Product/Process Change Notice (PCN)

PCN #: ConMM_160119_design change

Products Affected: 69015700xx7x_69036729xx76

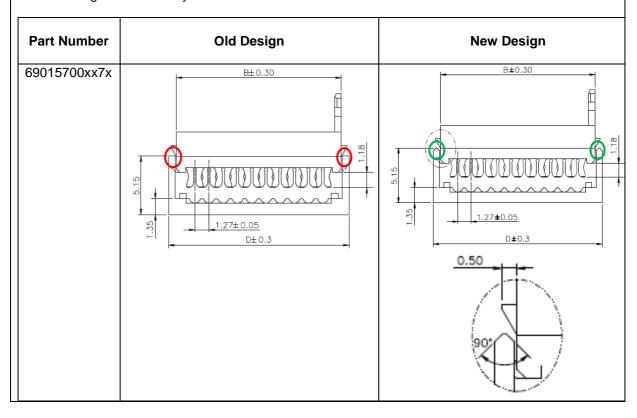
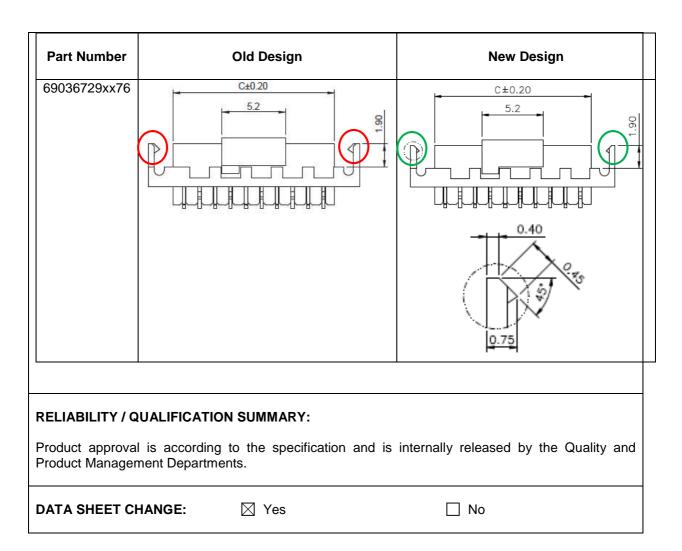
To ensure an improved product assembly, Würth Elektronik will change the design of the 69036729xx76 female part and the 69015700xx7x male IDC.

Würth Elektronik add bevel on the original design of 69036729xx76 base and 69015700xx7x cover to let the mating more smoothly.
